CNL-17-035

Subject: **Proposed Technical Specifications (TS) Change TS-505 - Request for License Amendments - Extended Power Uprate (EPU) - Supplement 38, Spent Fuel Pool Criticality Safety Analysis - Updated Information**

**Updated Responses to NRC Requests for Additional Information
SFP-RAI 5 and SFP-RAI 12**

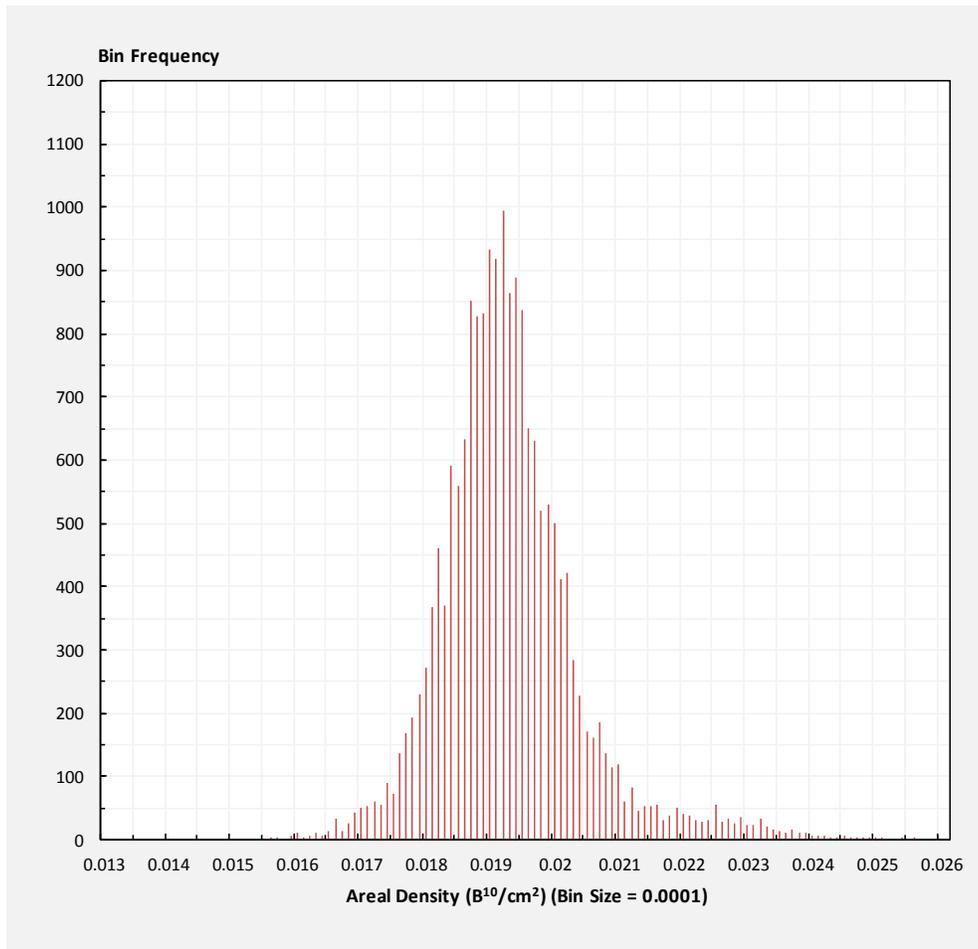
ANP-3160 states that the Boral is modeled using the design minimum B-10 areal density. The staff was unable to locate information describing how the Boral installed in the BFN SFP racks was verified to meet this minimum value, including any applicable measurement uncertainties. Provide an explanation of how the minimum B-10 areal density used in the SFP criticality analysis bounds all of the Boral plates installed in the BFN SFP racks.

Since the original response to this RAI was submitted, records were recovered from the manufacturer pertaining to Boral plates utilized in the BFN racks. The BFN SFP racks contain a total of 20,940 Boral plates.

With respect to verifying the minimum B^{10} areal density of the Boral plates, the associated Contract Specification states Boral plates can be certified by either chemical analysis or neutron transmission/(attenuation) measurement. The minimum required acceptable areal density value is $0.013 \text{ B}^{10}/\text{cm}^2$ per the associated Contract Specification and the minimum acceptable inspection value is $0.0135 \text{ B}^{10}/\text{cm}^2$, per the Brooks & Perkins, Inc. inspection procedure.

Utilizing the rack manufacturing data originally documented in support of the TVA response to NRC Generic Letter 2016-01 (TVA letter to NRC, "Tennessee Valley Authority (TVA) Response to NRC Generic Letter 2016-01, Monitoring of Neutron-Absorbing Materials in Spent Fuel Pools," dated November 3, 2016 (ML16308A477)), the following histogram can be generated for the 18,572 plates of BFN areal density measurement data.

The minimum measured areal density was $0.0155 \text{ B}^{10}/\text{cm}^2$. The distribution mean is $0.0192 \text{ B}^{10}/\text{cm}^2$ with a standard deviation of $0.001088 \text{ B}^{10}/\text{cm}^2$. The minimum manufactured value is ~20% greater than the contractual manufactured minimum requirement. The
